Rezoning Application: PD 26-0349

AGENCY REVIEW COMMENT SHEET

Revised: 4/15/2026

REVIEWER: James Ratliff, AICP, PTP, Principal Planner

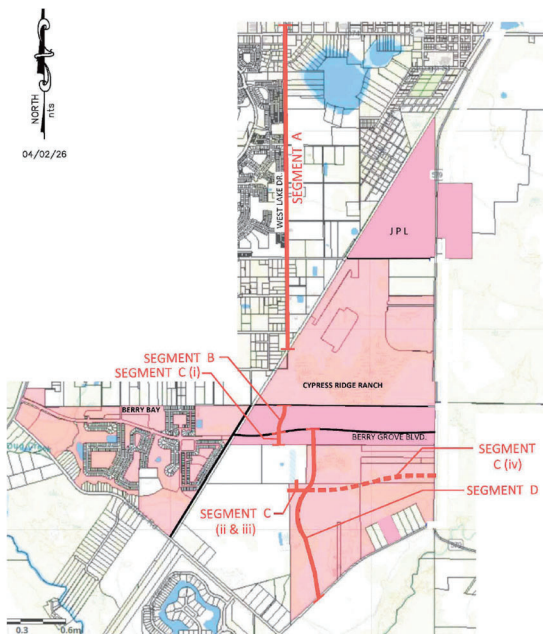
The Design Exception would authorize deviations from the TS-4 Typical Section (for 2-lane, Undivided, Urban Collector Roadways) as found in the 2021 Hillsborough County Transportation Technical Manual (TTM). Specifically:

1. Within Segment A, the developer shall widen/construct the roadway consistent with the TS-4 Typical Section, except that instead of the 5-foot sidewalks and 7-foot buffered bicycle lanes required per TS-4 the developer shall be permitted to install 10-foot-wide asphalt paths along both sides of the roadway. Additionally, the developer shall be permitted to reduce the required asphalt path separation as outlined below. The developer has proposed two typical sections for this segment (A-1 and A-2). Typical Section A-2 is the section where right-of-way is limited and/or there are design constraints. Use of Typical Section A-2 shall be minimized to the greatest extent feasible. The developer shall be permitted to reduce the required asphalt path separation between the closest edge of the asphalt path and the travel lane from 14-feet to 7-feet (for Typical Section A-1) and from 14-feet to 2-feet (for Typical Section A-2).

2. Within Segment B, the developer shall construct the roadway consistent with the TS-4 Typical Section, except that instead of the 5-foot sidewalks and 7-foot buffered bicycle lanes required per TS-4 the developer shall be permitted to install 10-foot-wide sidewalks along both sides of the roadway. Additionally, the developer shall be permitted to reduce the required sidewalk separation between the closest edge of the sidewalk and the travel lane from 14-feet to 6-feet. The developer shall also be permitted to eliminate the required 2-foot pedestrian clearance area between the back of sidewalk and edge of right-of-way.

1. Within Segment B:

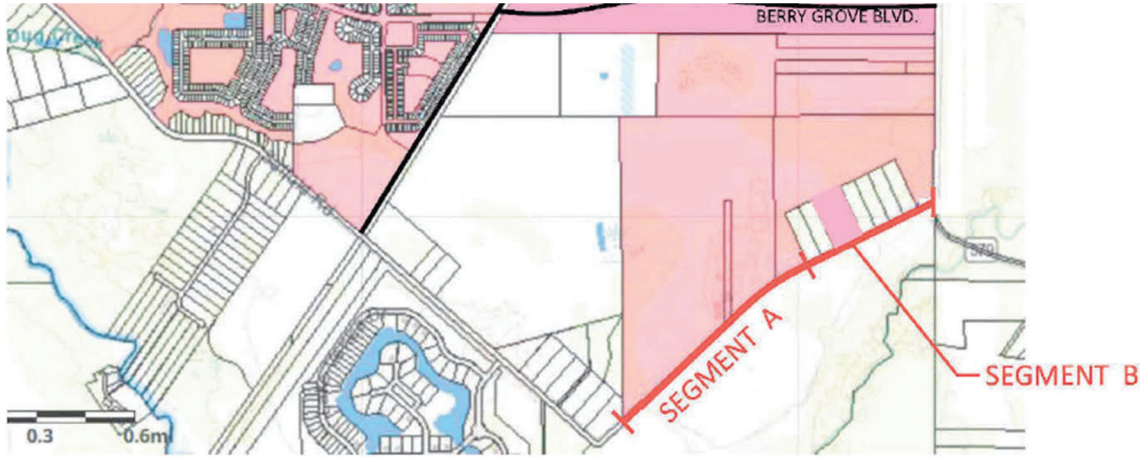
The Design Exception would authorize deviations from the 2021 Transportation Technical Manual (TTM) Typical Section – 7 (TS-7) (for 2-Lane, Rural Local and Collector Roadways). Specifically:

- a. The developer will be permitted to maintain the 10-foot-wide lanes in lieu of the 12-foot-wide lanes required pursuant to the Typical Section – 7 (TS-7) of the Transportation Technical Manual (TTM);

- b. The developer will be permitted to construct 6-foot-wide stabilized shoulders along both sides of the roadway, in lieu of the 8-foot-wide stabilized shoulders of which 5-foot is paved along both sides of the roadway as required pursuant to TS-7 of the TTM, thereby eliminating required bicycle facilities within this segment;

- c. The developer will be required to construct a 5-foot-wide sidewalk along the north side of the roadway; and,
- d. The developer will be required to dedicate and convey to Hillsborough County (for those parcel within the PD) a minimum of 48 feet of right-of-way north of the existing right-of-way centerline, or sufficient right-of-way necessary to permit construction (by others) of the same improvements planned for Segment A within Segment B, whichever is greater.

TYPICAL SECTION SEGMENT A SAFFOLD ROAD

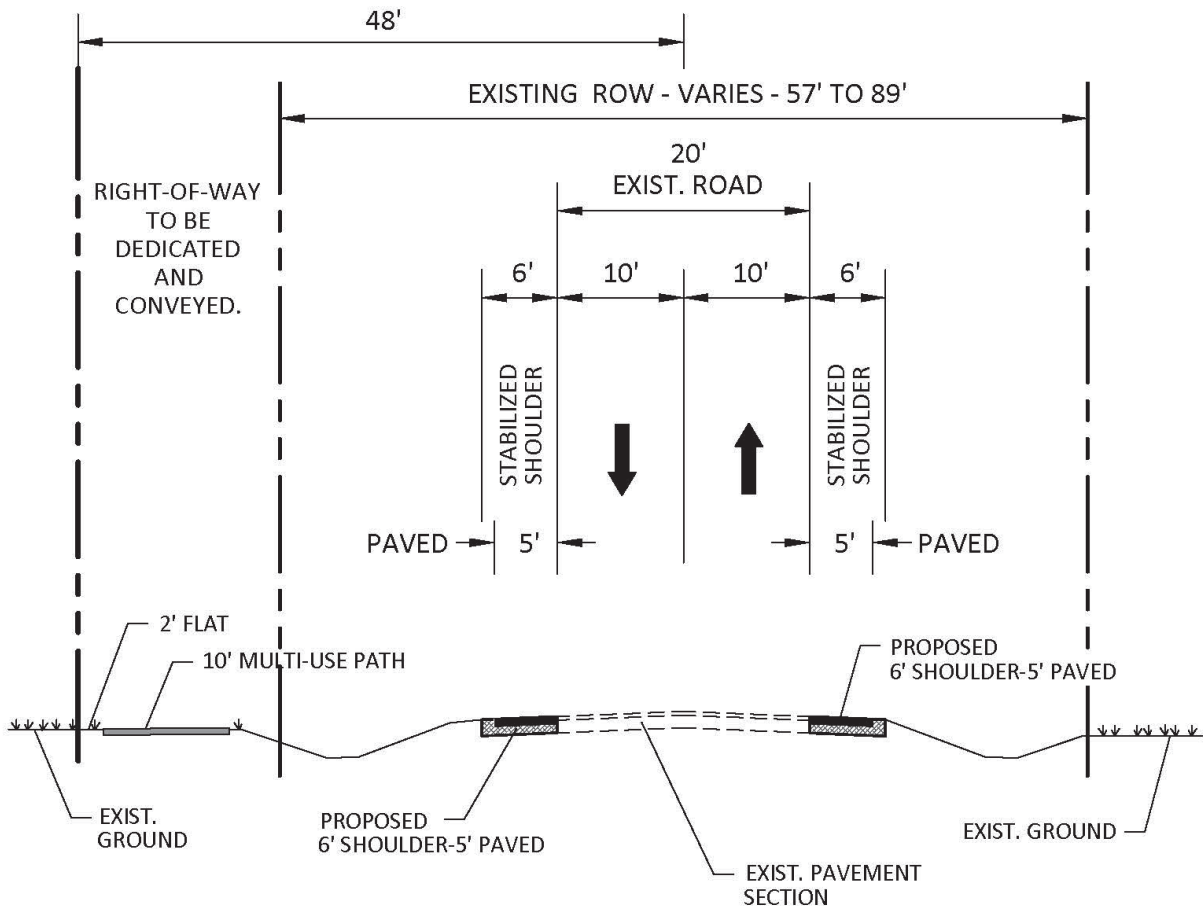
1. Right of Way – TS-7 has 96 feet of right of way. The right of way along the segment of Saffold Road varies between 71 feet to 89 feet. The developer will dedicate and convey the right of way required to provide improvements shown in Typical Section A or a total of 48 feet from the center line of the right of way, whichever is greater.
2. Lane Width – TS-7 has 12 foot lanes. The proposed section is to maintain the existing lanes at 10 feet. Due to limited right of way, 12 foot lanes cannot be provided.
3. Shoulder – TS-7 has 8 foot shoulders with 5 feet paved. The proposed section has 6 foot stabilized shoulder.

TYPICAL SECTION SEGMENT B SAFFOLD ROAD

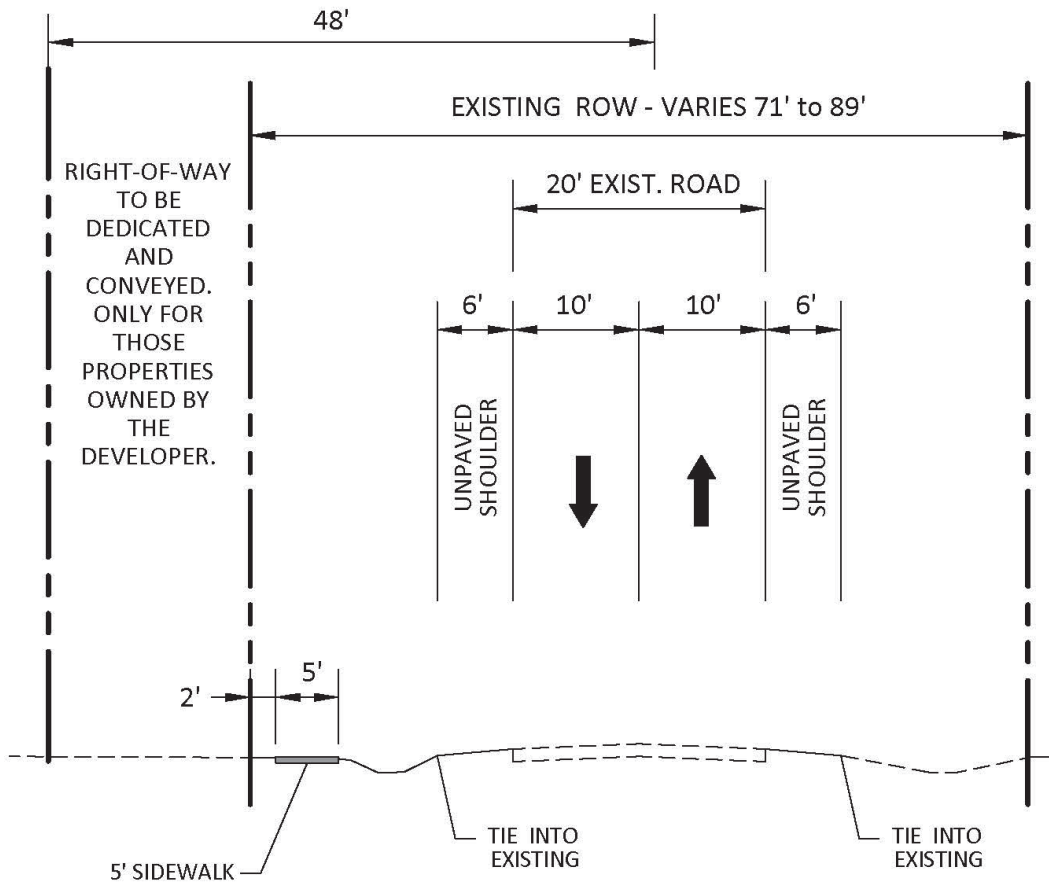
- 4. Sidewalk – TS-7 has 5 foot sidewalk on both sides of the roadway. A 5 foot sidewalk is proposed along the north side of Saffold Road.

TYPICAL SECTION C/D

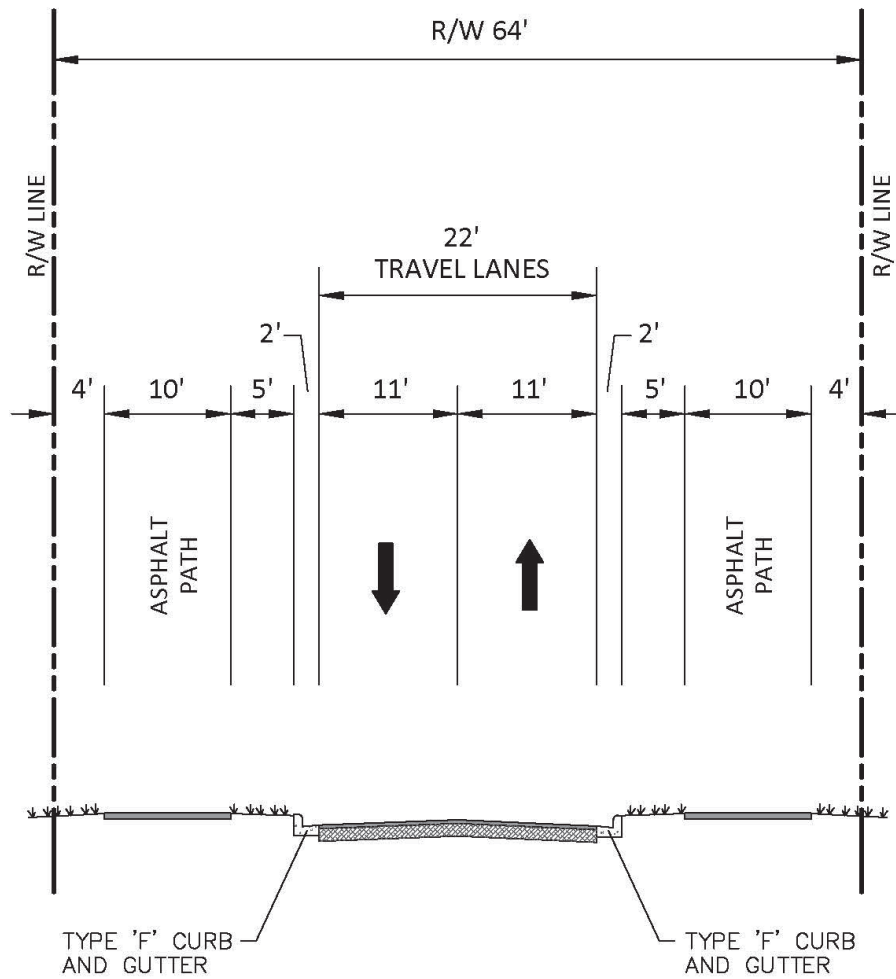
The proposed Typical Section is shown in Section C/D This section includes the following:

1. Bike Lanes – To match the typical section north of Bishop Road, 10 foot sidewalks are proposed on each side of the roadway in lieu of the bike lanes. From a safety standpoint, the 10 foot sidewalks provide a better option for students walking and riding bikes to school than students riding bikes within the roadway or pedestrian and bikes on a 5 foot sidewalk.
2. Sidewalk – 10 foot sidewalk on both sides of the roadway are proposed instead of the bike lanes. As stated above, given the roadway will serve the three (3) schools, the 10 foot sidewalks provide a better option for the school students.
